Product: **DG/S 1.1 DALI-Gateway, 1-fold, MDRC**

Type: **DG/S 1.1**

Current application program: **Dim Slave Light Scenes Dynamic 1f/1.1c**  
**DALI Firmware V1.4**

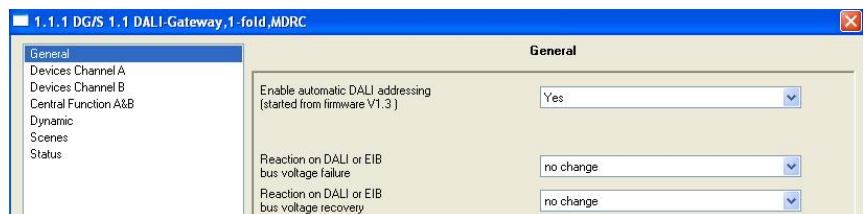
- Only DALI firmware has changed to V1.4  
(Devices with firmware V1.4 are signed on device shoulder with V1.4)
  - Application program *Dim Slave Light Scenes Dynamic 1f/1.1a* has not been changed and can be used unchanged.
  - DG/S 1.1 with firmware V1.3 (signed „V1.3“ on device shoulder) do not carry out a DALI addressing.
  - Keep in mind the information for *Dim Slave Light Scenes Dynamic 1f/1.1a* (DALI firmware V1.3).
  - Update to DALI firmware V1.4 is only possible in factory.
-
